Subsurface Wastewater Disposal Plan

STATE OF MAINE
DEPARTMENT OF HUMAN SERVICES
AUGUSTA, MAINE 04333

Subject: New System Variance to the Maine Subsurface Wastewater Disposal Rules, Buzzell property, Mt. Vernon Road, Augusta

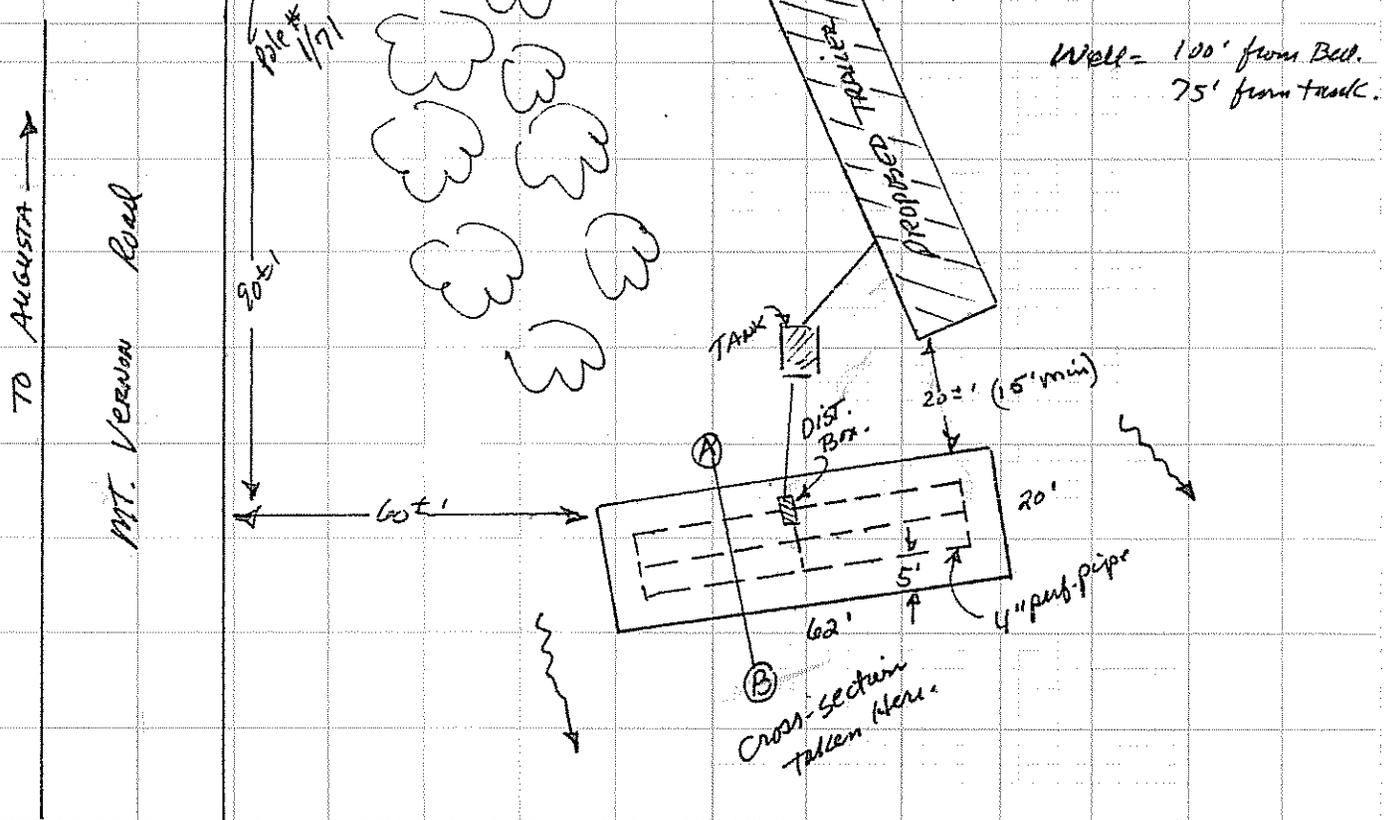
The installation of a 1000 gallon septic tank followed by a 62'x20' bed system.

This office points out that the rules require that the Site Evaluator, Mr. Goodwin, be retained to stake out the system and elevations at the time of construction of the system.

In all other respects the installation is to comply with the Subsurface Wastewater Disposal Rules and follow the plan submitted with this proposal.

Subsurface Wastewater Disposal Area Cross-section

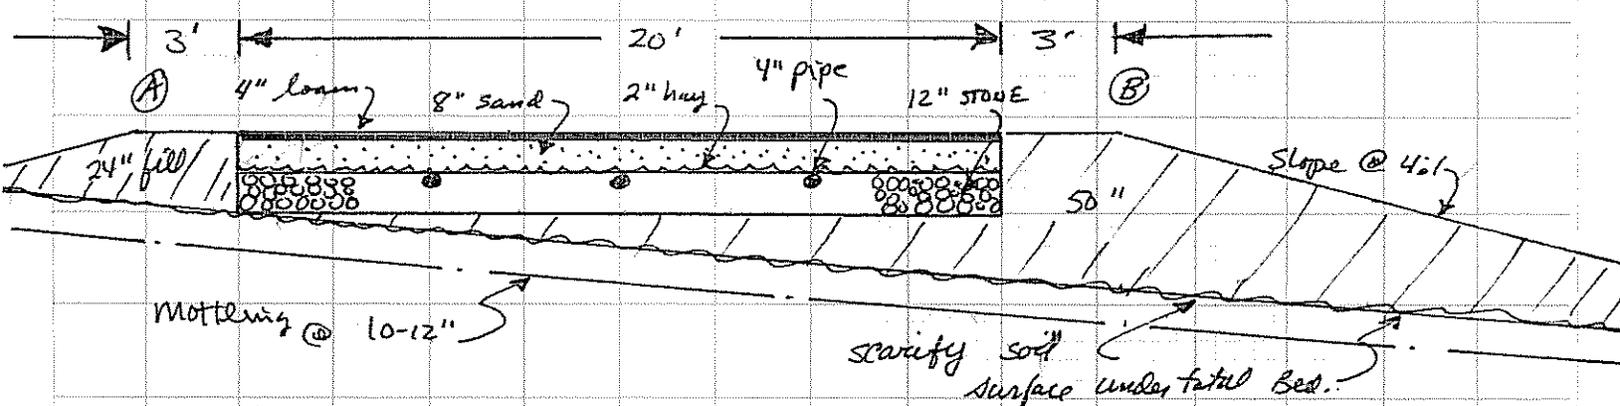
At least 24 inches and 50 inches of fill shall be applied on the uphill and downhill sides of the disposal field, respectively. The fill shall be of a texture similar to the original soil and will provide a 12 inch separation between the bottom of the disposal bed and the seasonal high water table and impervious layer. The fill must be extended in all directions as required by Section 11.D of the Subsurface Wastewater Disposal Rules.
